**AGENDA
PLANNING COMMISSION
CITY OF WYOMING, MINNESOTA
JUNE 8, 2021
7:00 PM**

3. Site Plan Review Sp-21-001 Widseth Smith and Nolting
Location: 5368 266th Street
Applicant: PMI Construction Services

CITY OF WYOMING Planning Commission

TO: Planning Commission
FROM: Tom Ramler-Olson, City Planner
Fred Weck
MEETING DATE: June 8, 2021
RE: Site Plan Review of Project at 5368 266th Street
APPLICANT: PMI Construction Services
OWNER: Widseth Smith and Nolting (WSN)
PROPERTY: PIN 210022600
FILE NO.: Sp-21-001

NEW WIDSETH OFFICE
WIDSETH
WYOMING, MN
SITE PLAN

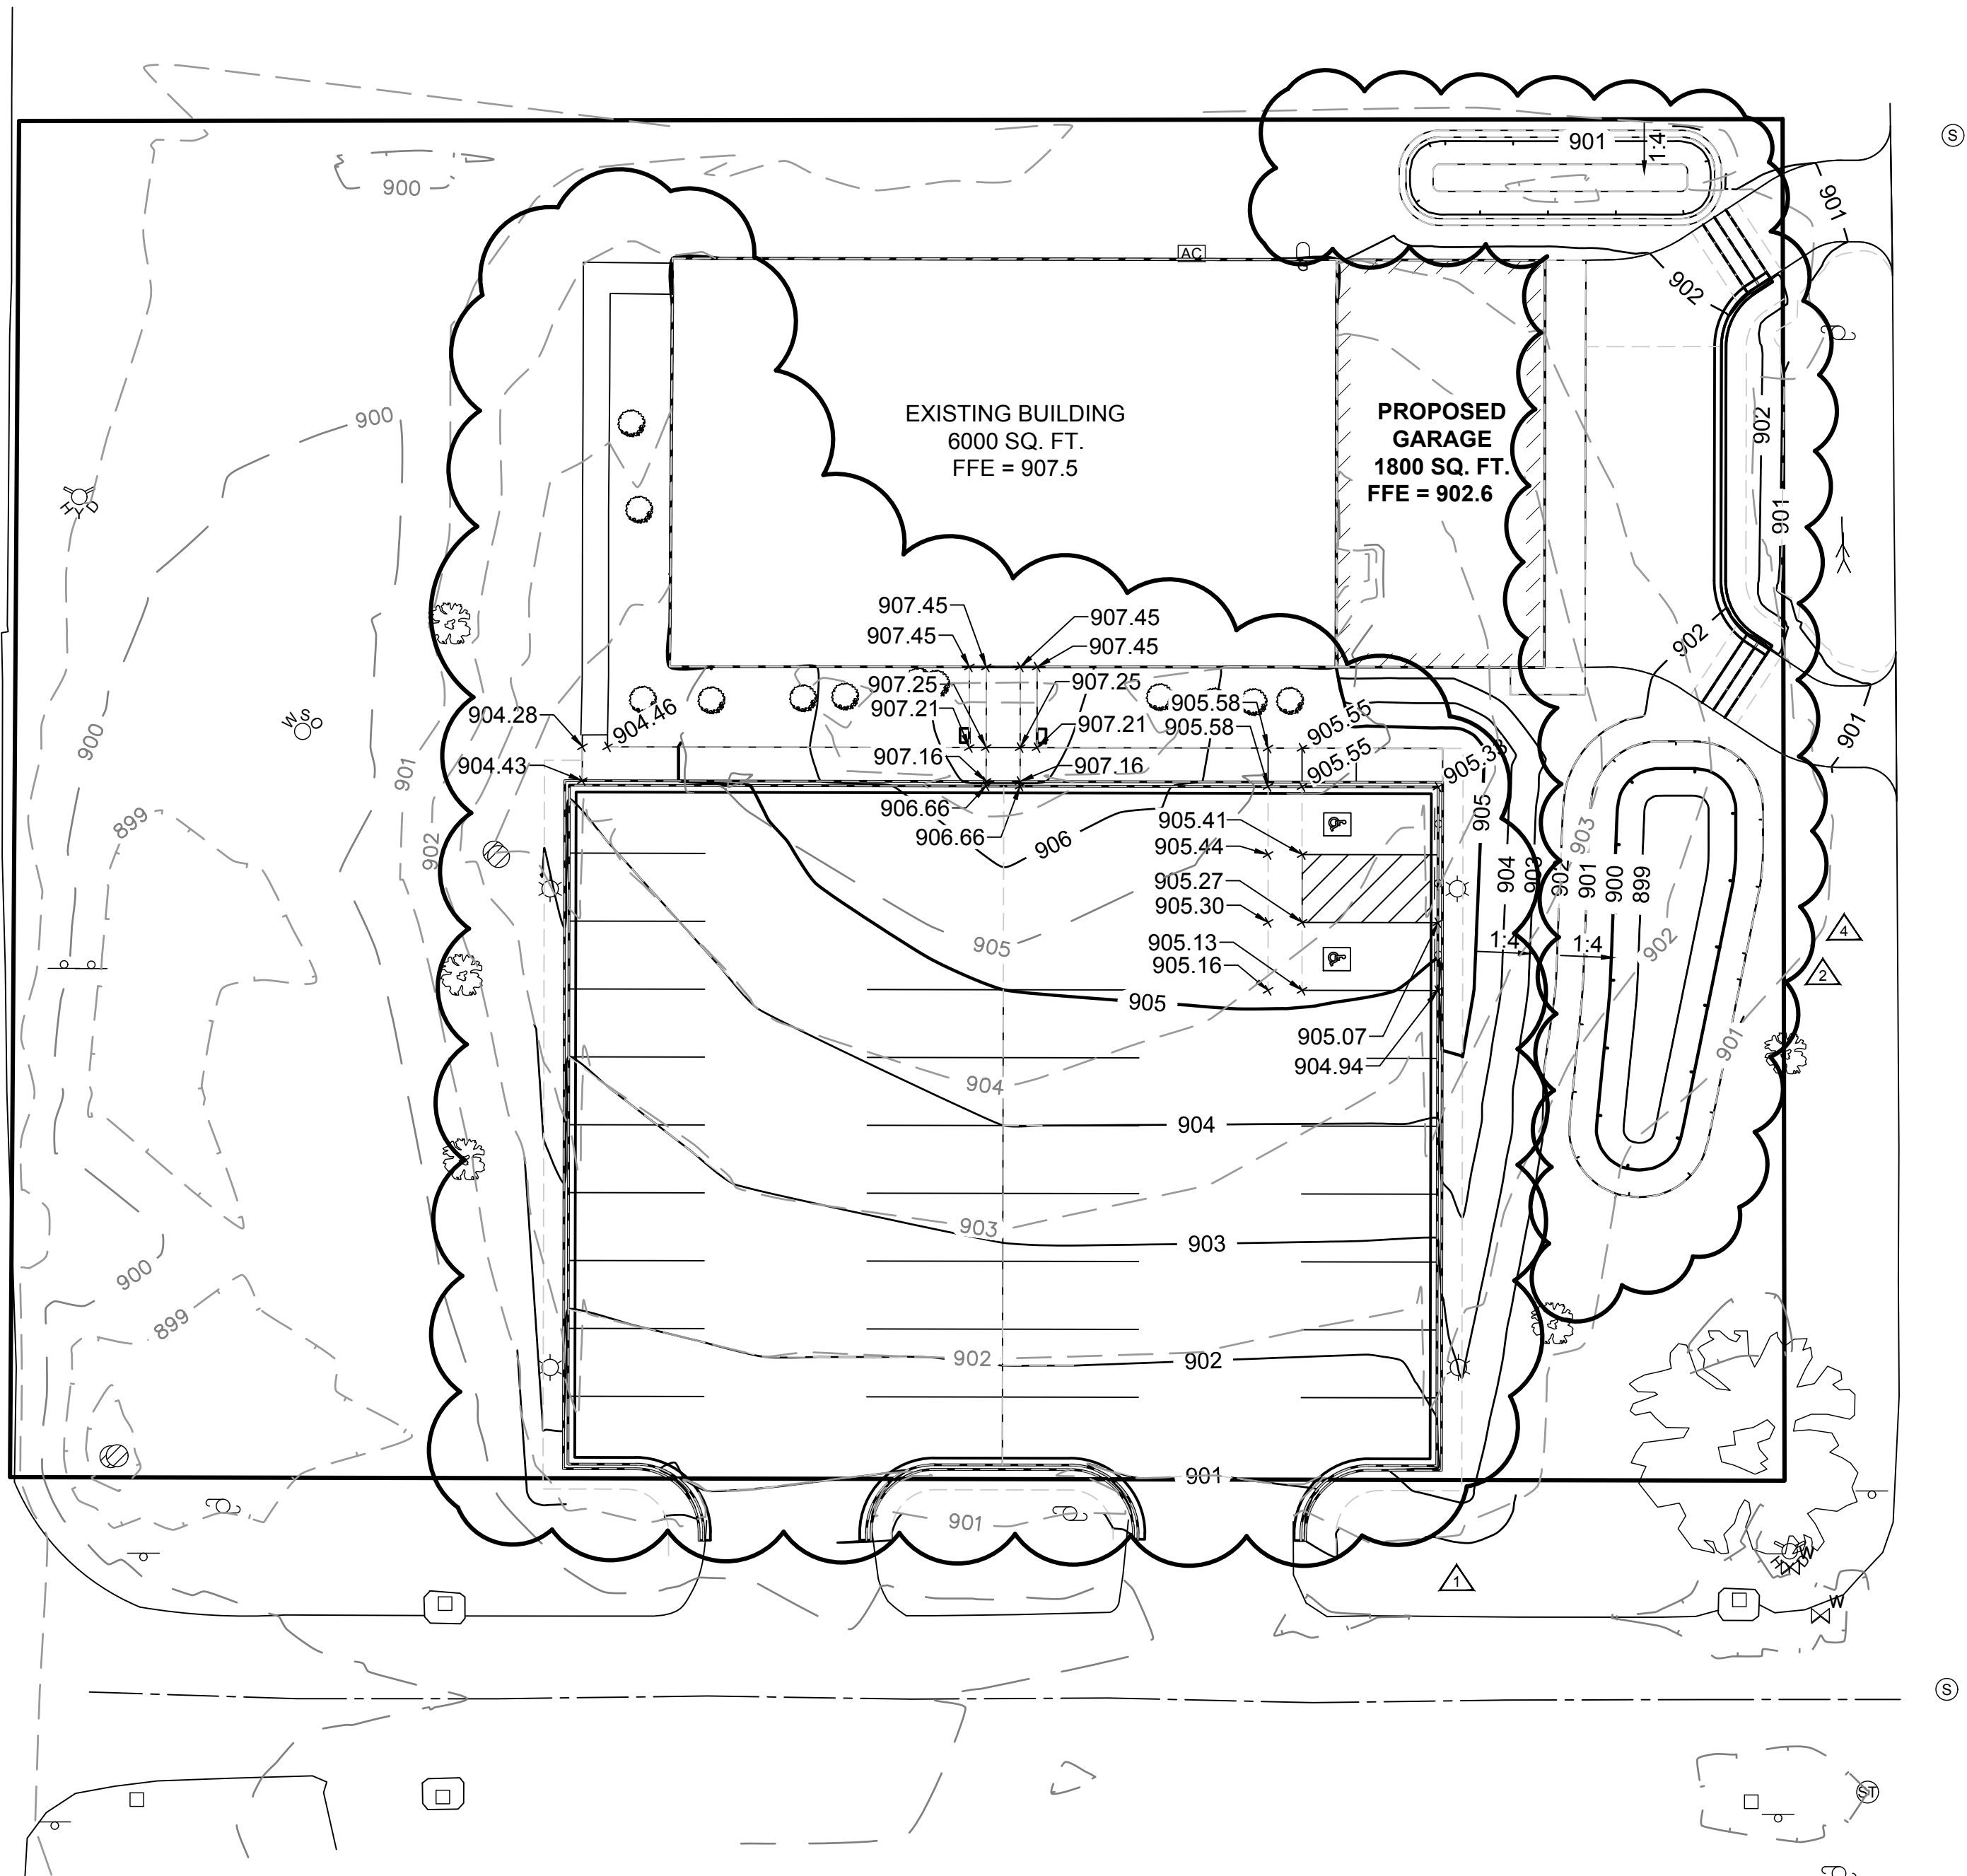
The removal of the four trees described above will leave the parking lot even more exposed to homes to the east than the current condition. Section 40-720 requires that commercial uses that abut a residential district or are separated from a residential district by only a street other than a collector or arterial shall provide screening along any adjacent side. Section 40-674 goes on further to require that all parking lots with spaces for four (4) or more cars be screened and landscaped from abutting residential uses or districts by a wall, fence, or densely-planted compact hedge or tree cover not less than four (4) feet in height. These conditions should also be addressed in the requested landscape plan.

Removal plans provided by the applicant show removal of a garbage enclosure to accommodate the garage access drive. However, a replacement for the garbage enclosure is not shown on the site plan or any other drawing. Section 40-723 requires that trash containers provided in conjunction with commercial uses be screened by an enclosure constructed on three (3) sides with break-off block, face brick, or masonry. Other design standards are described further in that Section of the Ordinance.

Existing conditions show there are no sidewalks along any side of the subject property that abuts the right-of-way. They also show a concrete walkway that connects the main access to the edge of the abutting right-of-way, Felton Ave. The applicant plans to remove that walkway, and there are no plans to replace it, which leaves the only access point to the main entry at the driveway entrances to the parking lot. Section 40-690 requires that pedestrian access be provided onto the site. The access should be provided in such a way that minimizes the conflict between pedestrians and traffic at all points of pedestrian access to on-site parking and building entrances. The site plan drawing shows a new walking path between the principal structure and the parking lot. However, it is designed to be only five feet in width, which conflicts with Section 40-692 (2) that states that walkways will be a minimum of 6 feet of unobstructed width.

1. A lighting plan consistent with provisions found in Section 40-565 (2) and containing information listed in Section 40-567
2. A landscape plan that includes information listed in Section 40-555 (1) (b) and the required tree plantings per Section 40-555 (2)
3. Parking lot screening consistent with Section 40-674
4. A revised pedestrian walkway proposed between the parking lot and building and new pedestrian walkway to replace the one proposed to be removed, the standards for which are in Section 40-690
5. A sign plan consistent with standards described in Article VII Division 28
6. All outstanding information related to drainage

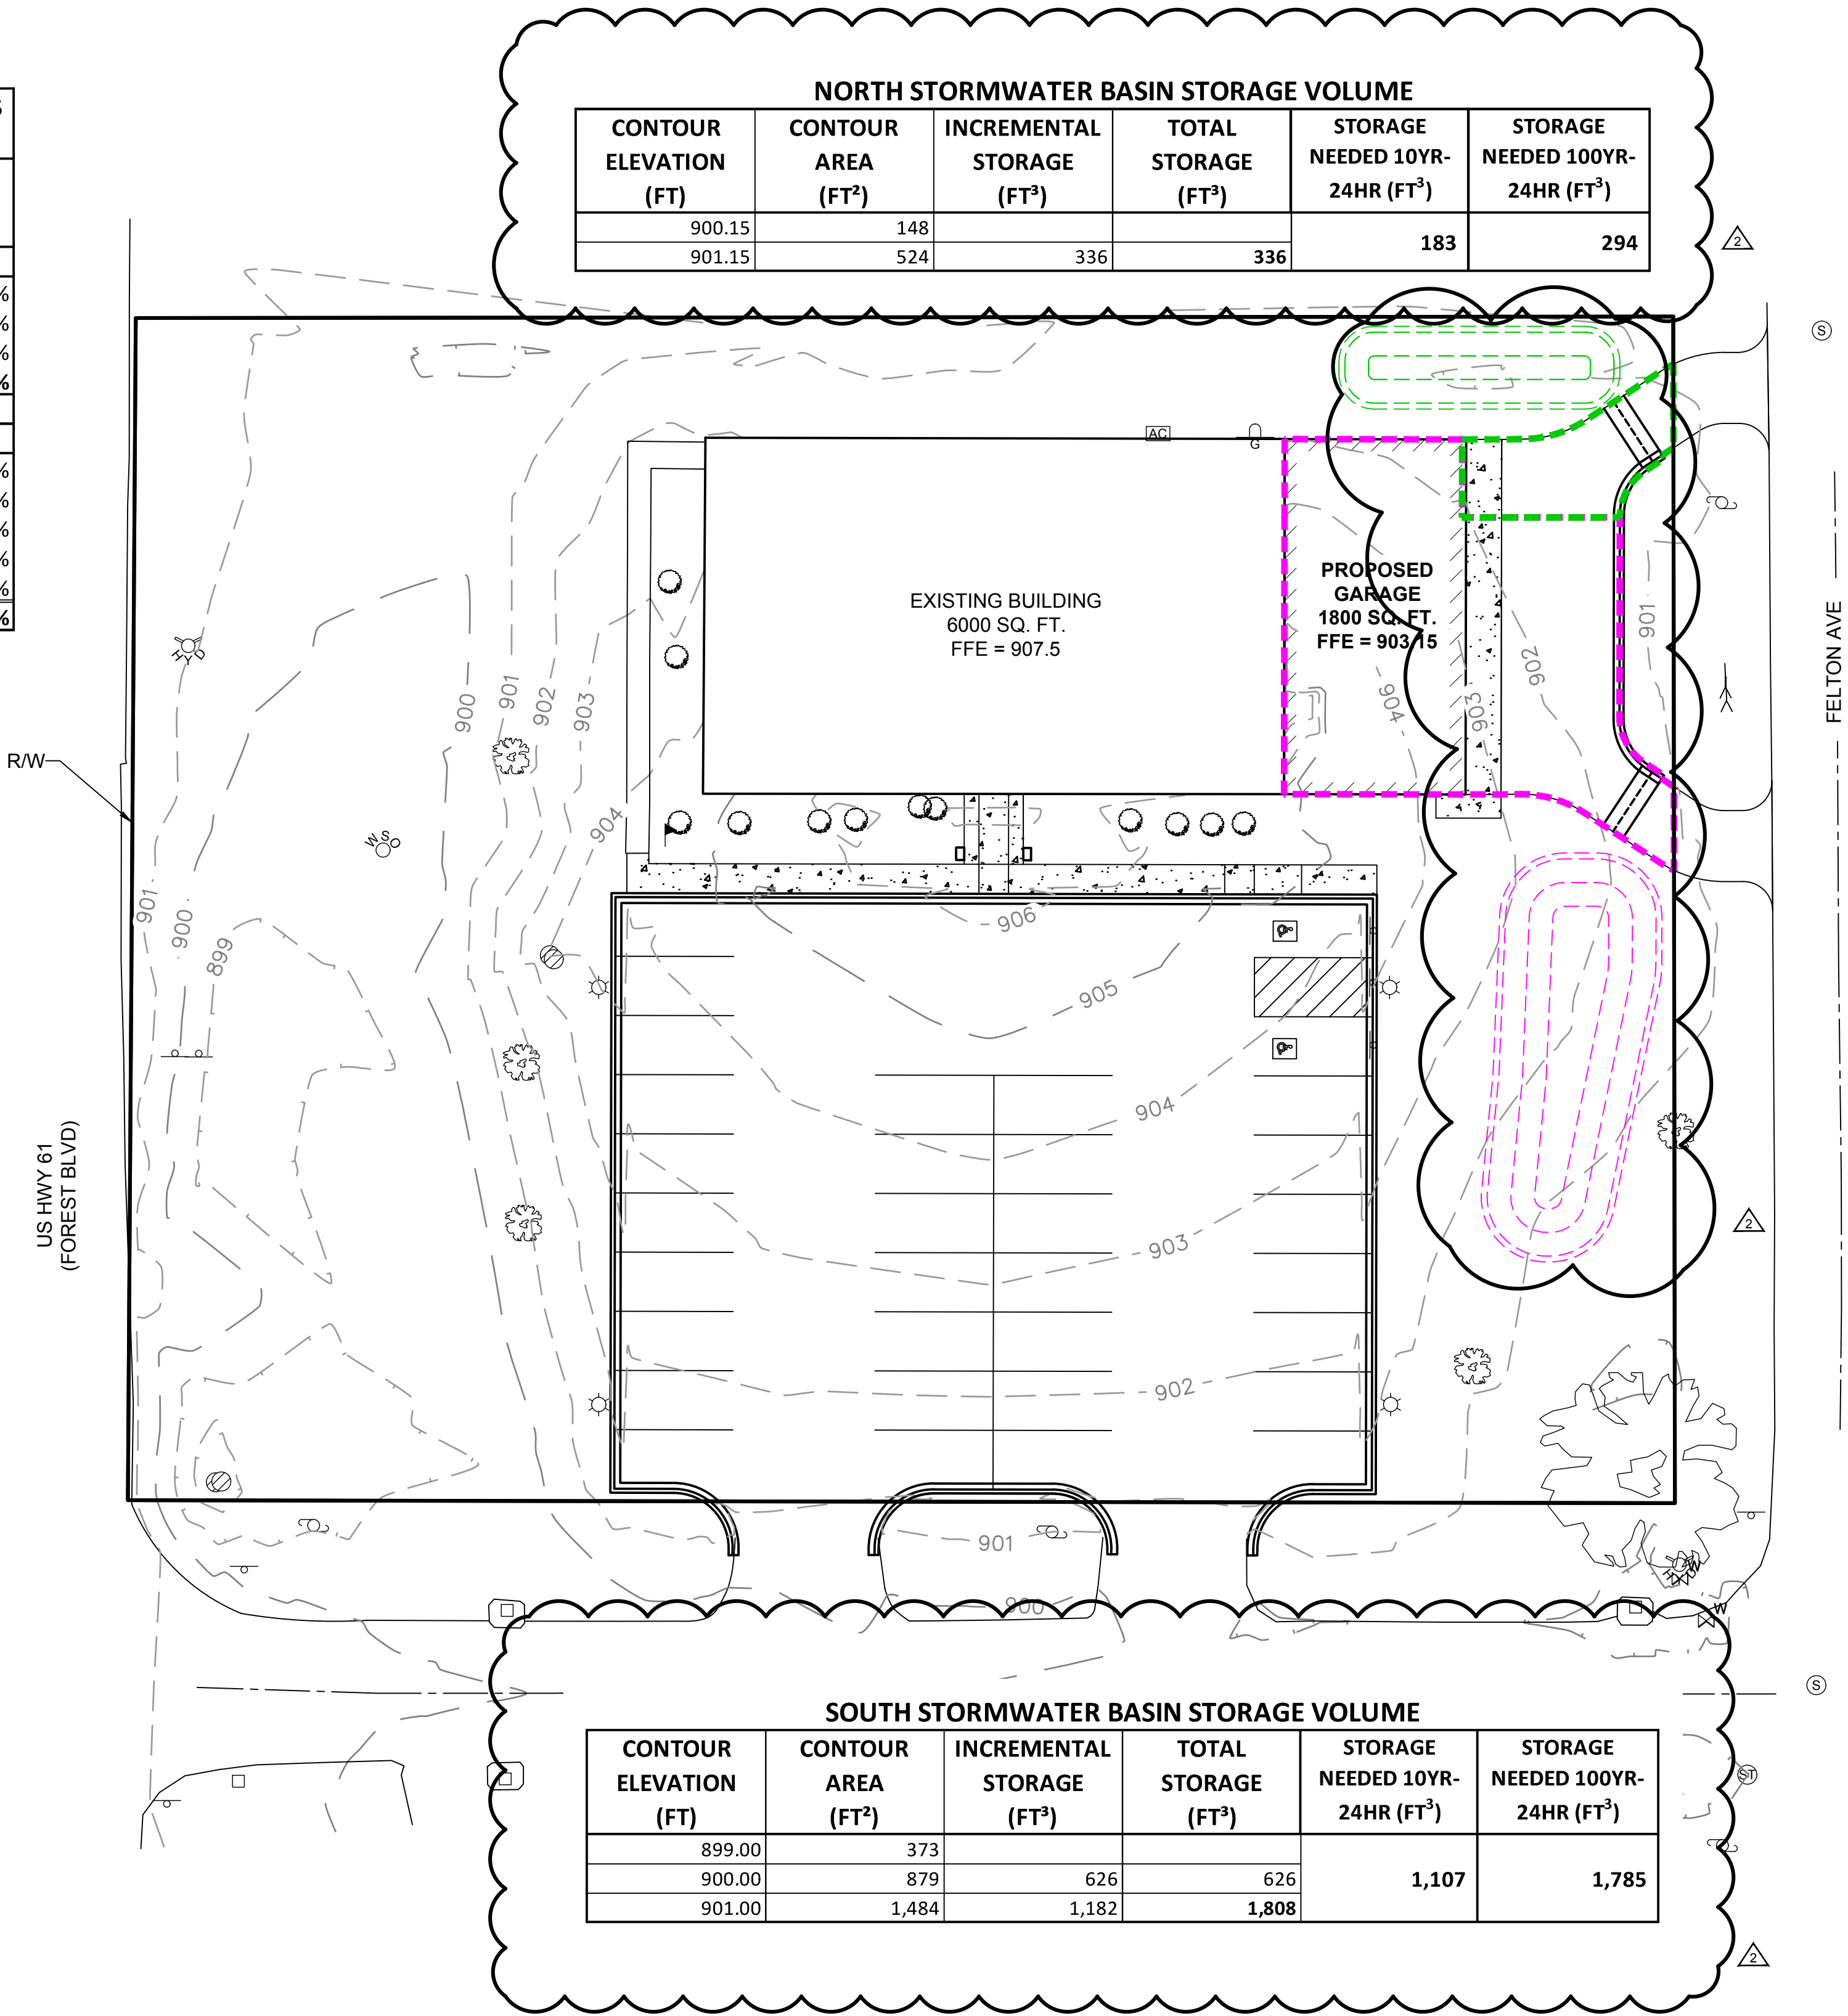
The applicant is proposing two stormwater basins near the expansion to provide rate control for the site; however, based on the information provided, it is unclear if the basins are proposed to infiltrate. If the applicant is proposing to infiltrate within the basins soil borings or other documentation on the soils should be provided to confirm the basins will infiltrate as designed and to confirm the site will meet rate control requirements.

The emergency overflow elevations and locations for both basins should be noted on the plans. The emergency overflow should be a minimum two feet below the adjacent low building opening to meet freeboard requirements.

The finish floor elevation (FEE) of the proposed garage differs in elevation on sheets C6.0 and C6.0A. The FFE should be consistent on all plan sheets. The FFE should be set at a minimum of 903.15 in order to meet freeboard requirements with respect the adjacent basins.
